2 COMMENTS AND RESPONSES

RE: Comments on Corte Madera Creek Flood Risk
Management Project, Phase 1 Draft EIR

2.4.1 Response to Letter B1: Friends of Corte Madera Creek Watershed

Figure 2.6-1 Staging, Stockpile, and Temporary Work Areas

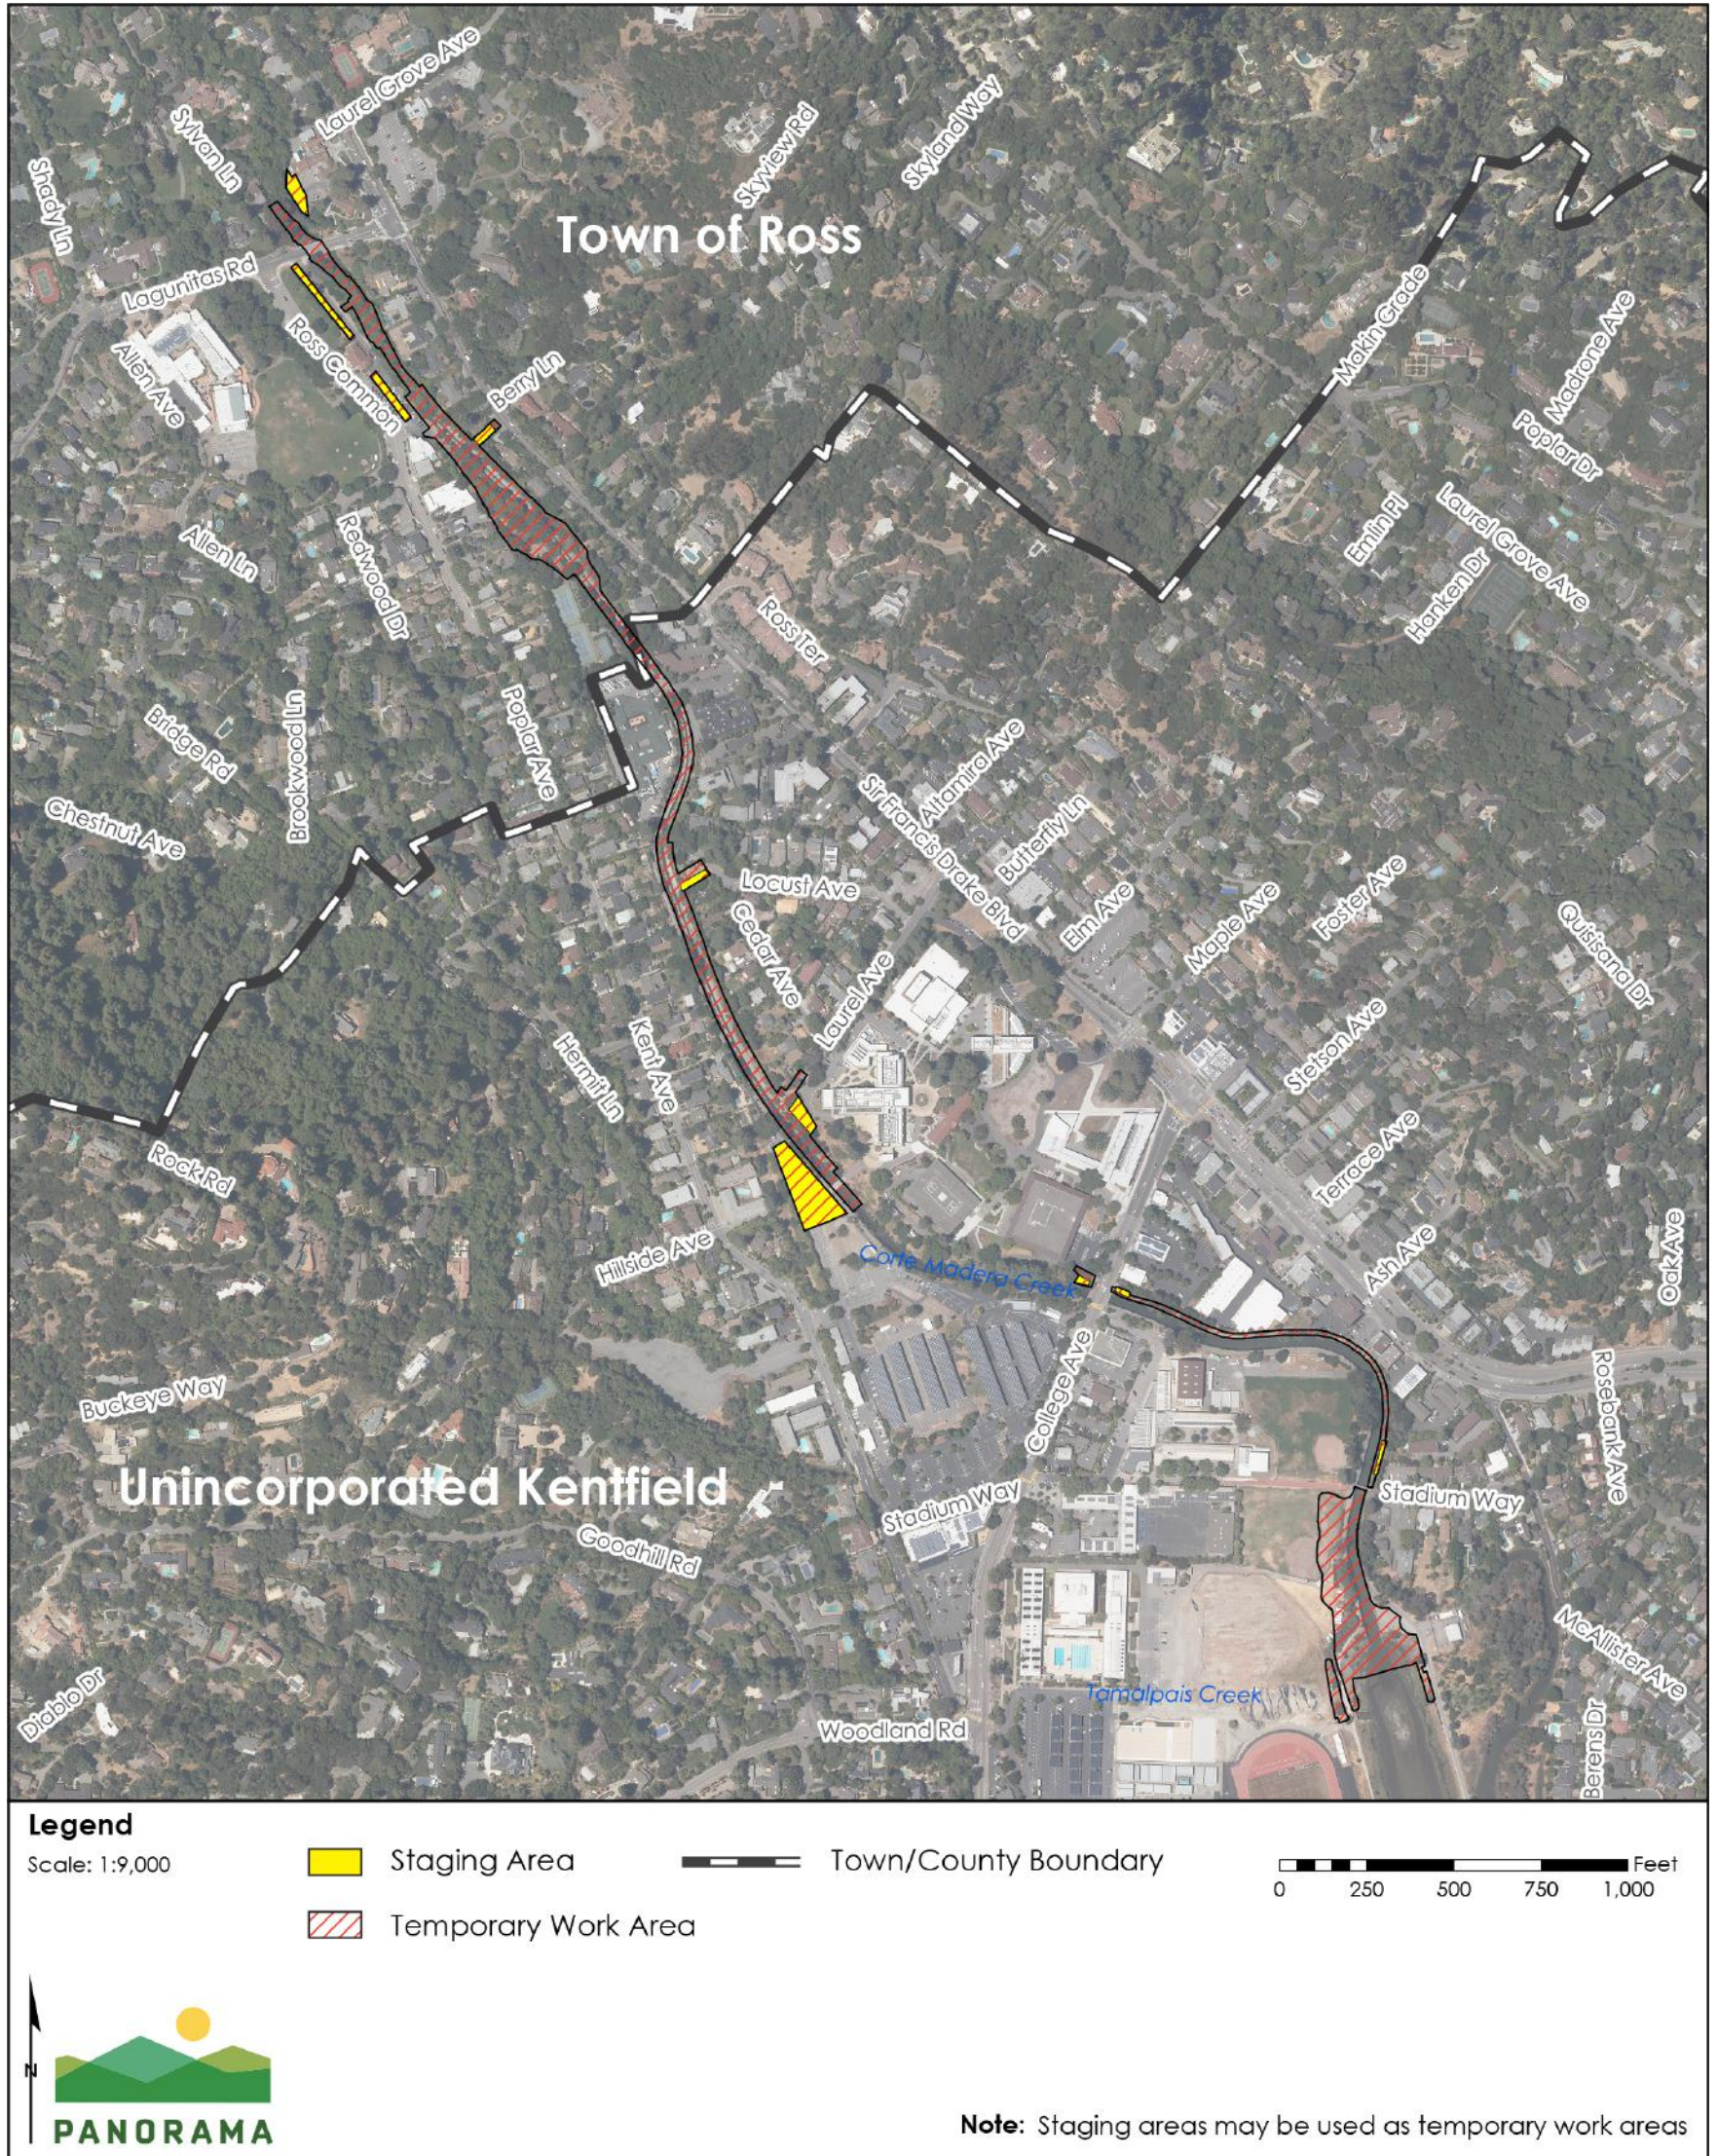
Figure 2.6-1; Figure 3.3-3; Figure 3.9-3 Remove staging area shown in COM project area. See Sheet C17 of 65% design plans for designated staging area.

B1-31 The commenter states that the staging area shown in the College of Marin Project area should be removed from Figures 2.6-1, Figure 3.3-3, and Figure 3.9-3.

Figures 2.6-1, 3.3-3, 3.9-3, and 3.15-3 have been revised as follows to show the correct footprint for the Lower College of Marin Project. These maps do not include a staging area at the location of a turn-around for emergency vehicles required by the Kentfield Fire District nor a planted area beyond the multi-use path on the left bank of the creek:

Figures 2.6-1, Figure 3.3-3, and Figure 3.9-3 in the Draft EIR have been revised to remove the staging area shown in the College of Marin Project area as shown in response to B1-25 above.

Figure 3.2-2 Sensitive Receptors within 1,000 Feet of the Project Area

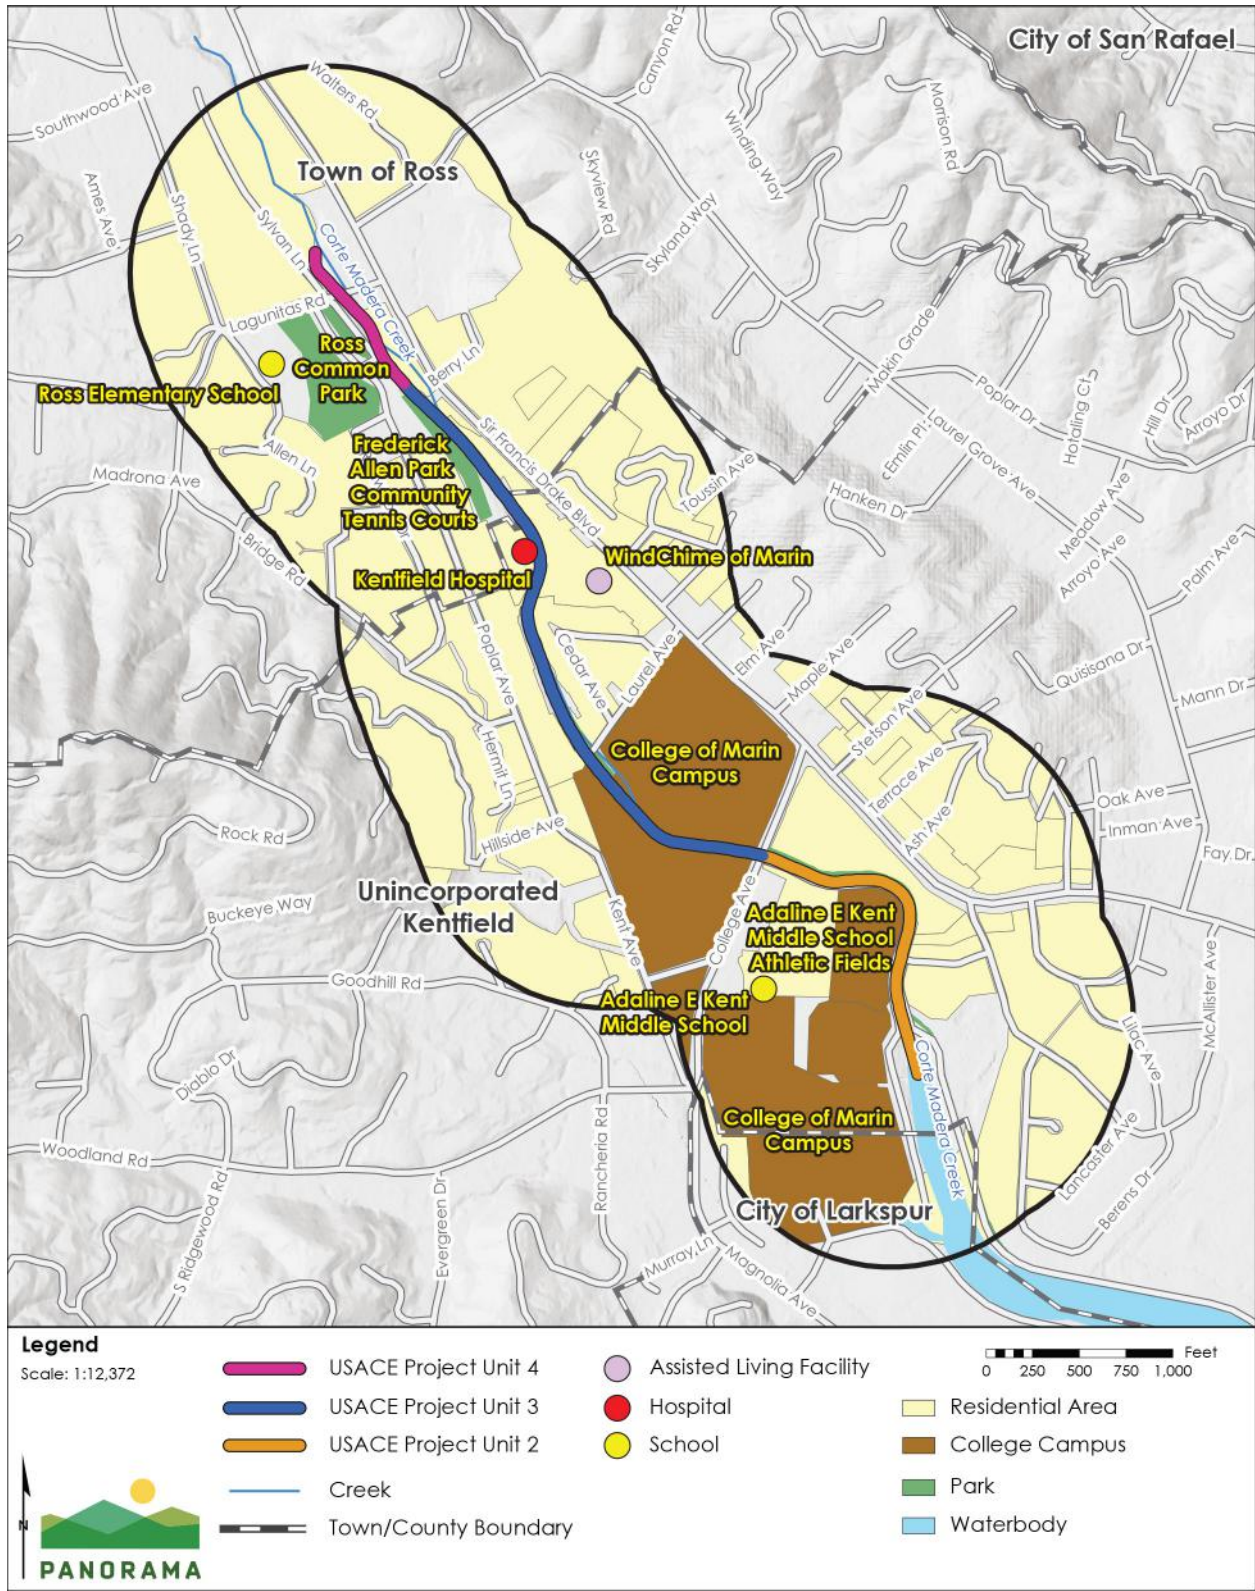
Figure 3.2-2; Figure 3.10-3 The site of COM's M&O Facility is mapped as Park (green). It should be mapped as College Campus (brown).

B1-33 The commenter states that the College of Marin’s Maintenance and Operations Facility is mapped as Park (green) and should be mapped as College Campus (brown) in Figure 3.2-2 and Figure 3.10-3 in the Draft EIR.

Figure 3.2-2 and Figure 3.10-3 have been updated as follows in the Draft EIR, to map the College of Marin’s Maintenance and Operations Facility correctly as College Campus:

Figure 3.12-2 Parks and Recreational Facilities in the Project Area

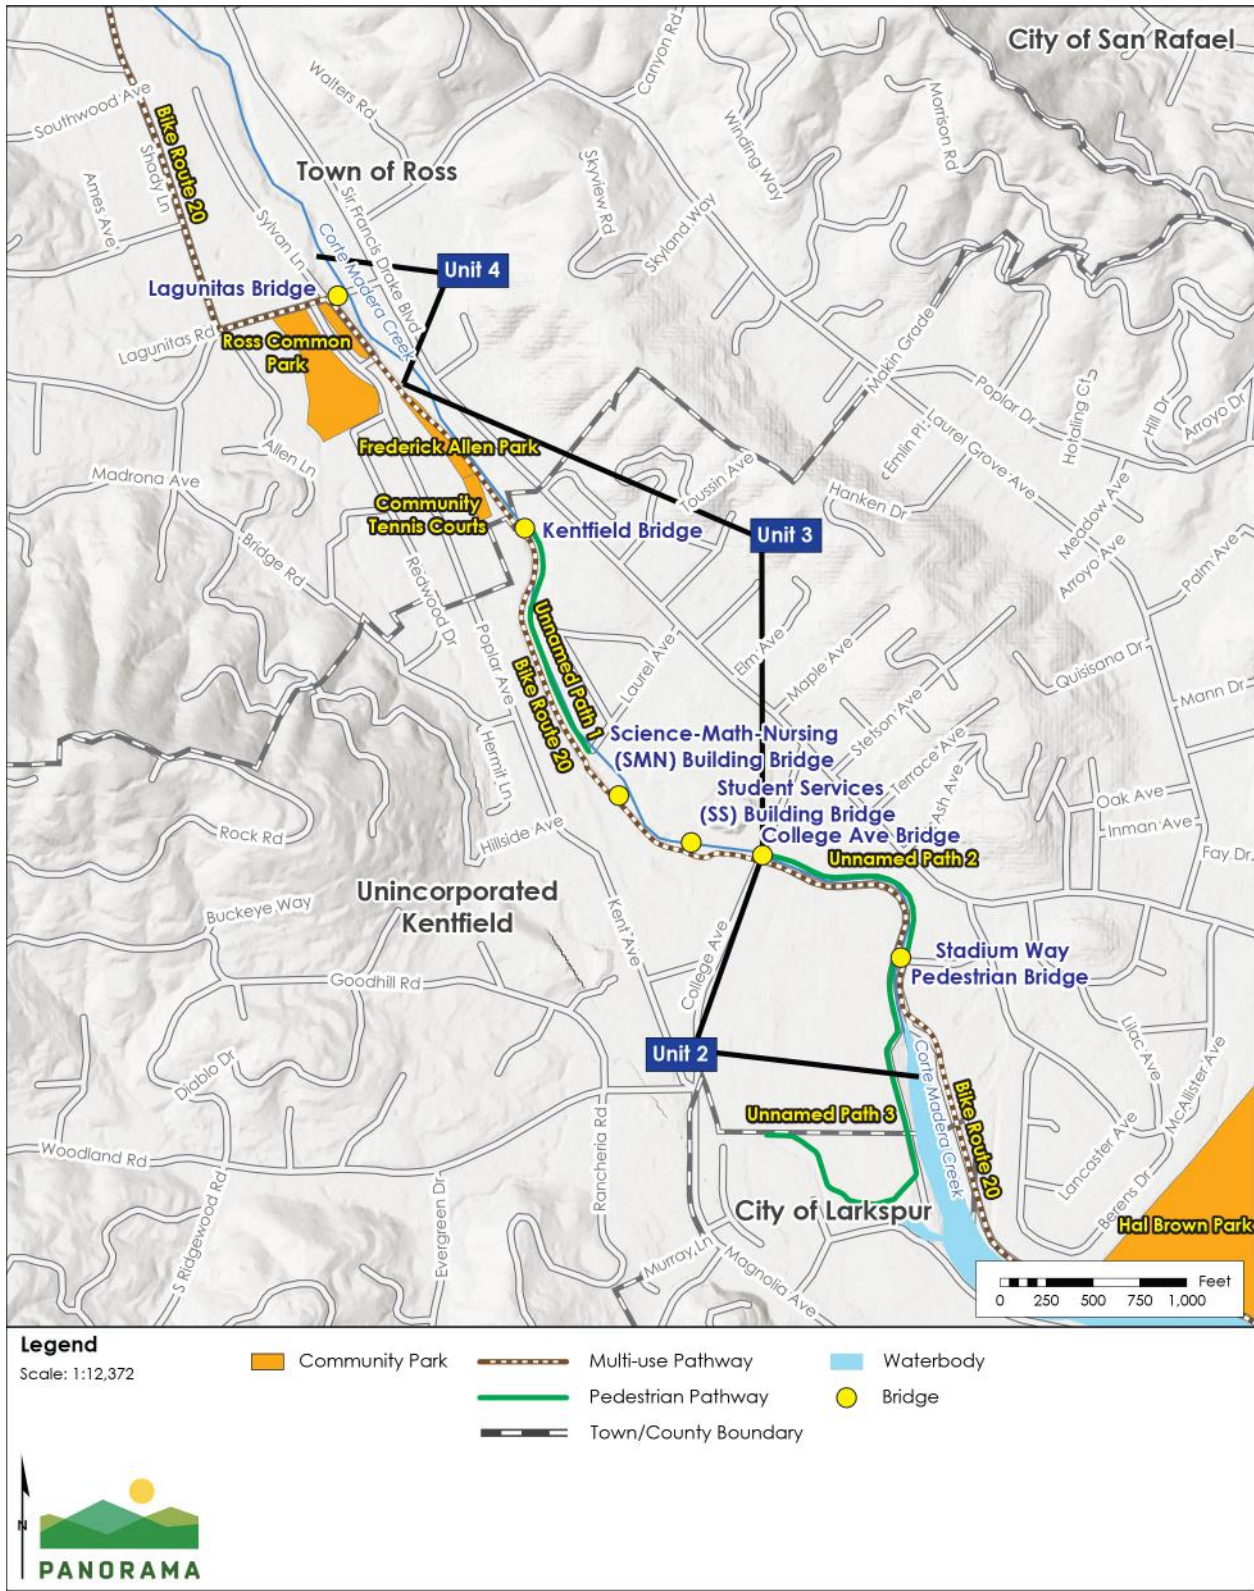
Figure 3.12-2 The COM M&O Facility is mapped as a campus recreation area. Remove that area from the map of recreational facilities.

B1-43 The commenter states that the College of Marin Maintenance and Operations Facility should be removed from Figure 3.12-2.

Figure 3.12-2 has been revised in the Draft EIR as follows, removing the College of Marin Maintenance and Operations Facility.

Figure 3.13-1 Local Transportation Network

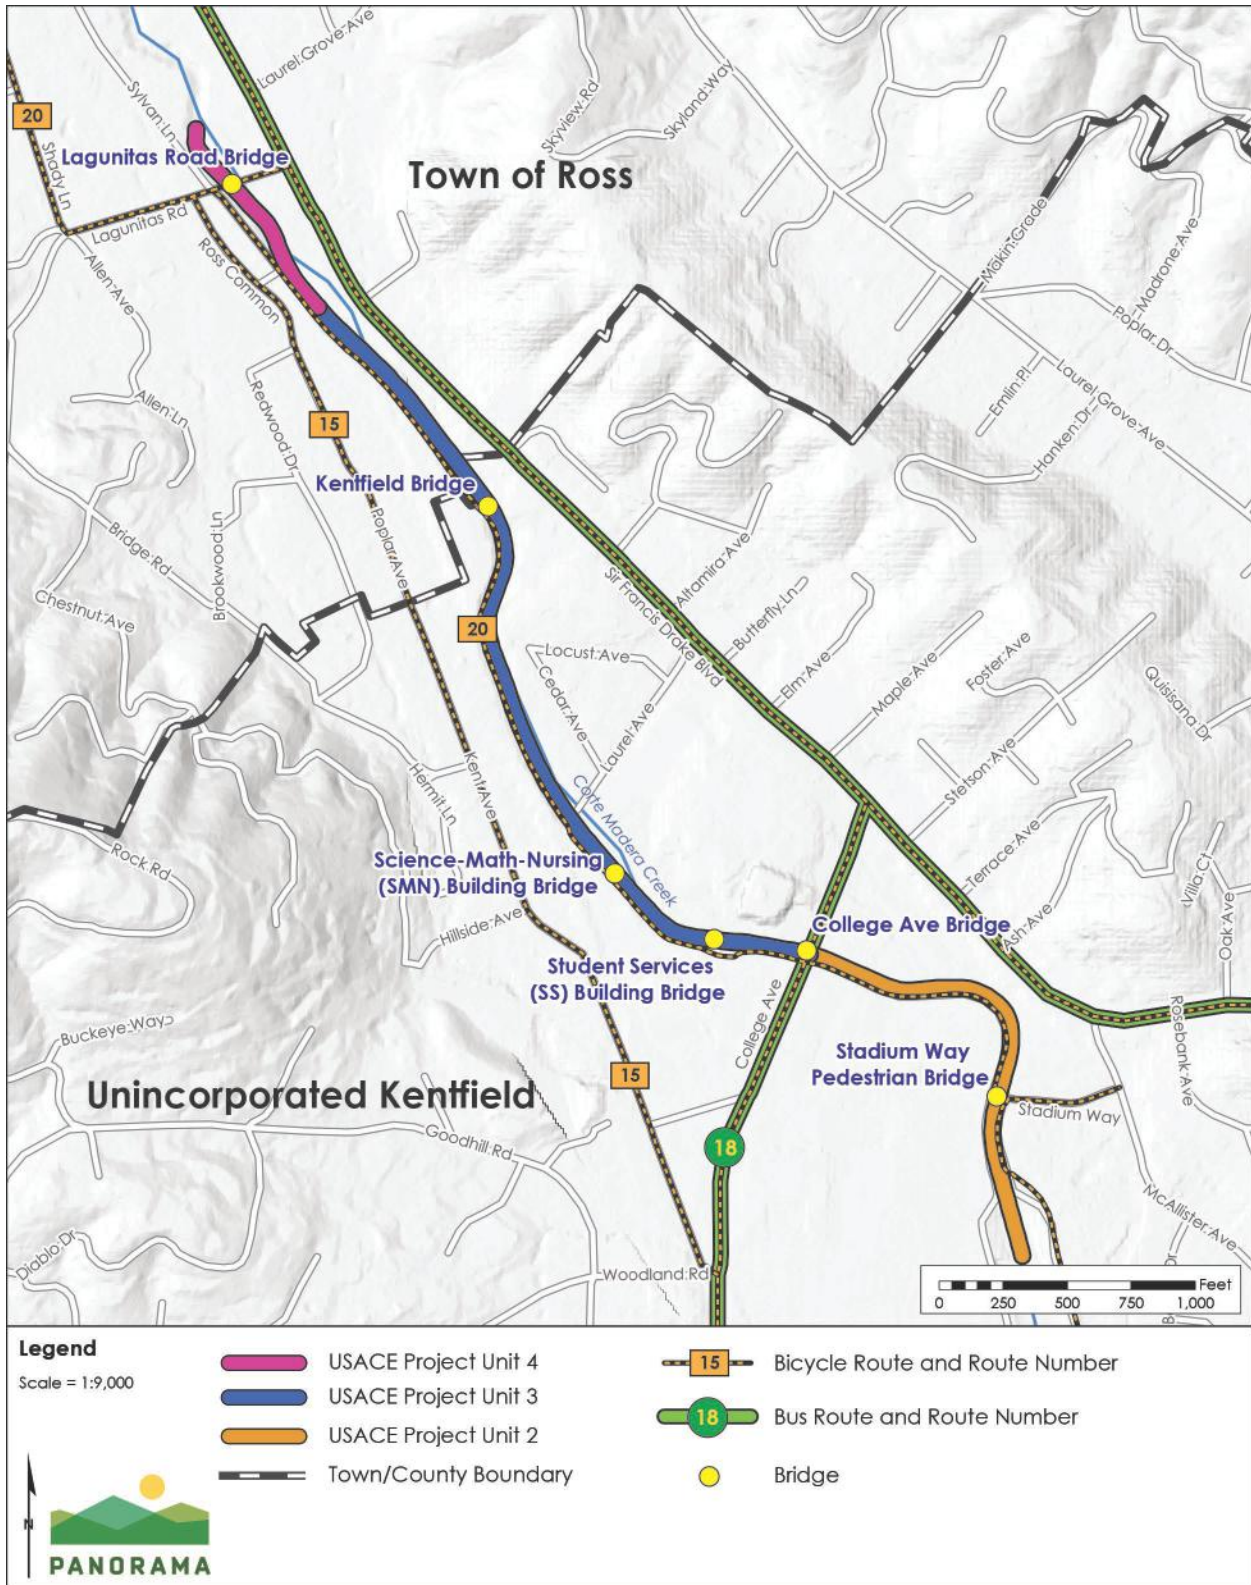
Figure 3-13-1 Unnamed Path #3 is mapped as a bicycle route. It is virtually never used by cyclists and the Marin County Bicycle Coalition does not consider it a bicycle route.

B1-45 The commenter states that in Figure 3.13-1 in the Draft EIR, Unnamed Path #3 is mapped as a bicycle route.

Figure 3.13-1 has been revised as follows in the Draft EIR to remove the bike route from the right bank of the creek south of Stadium Way.
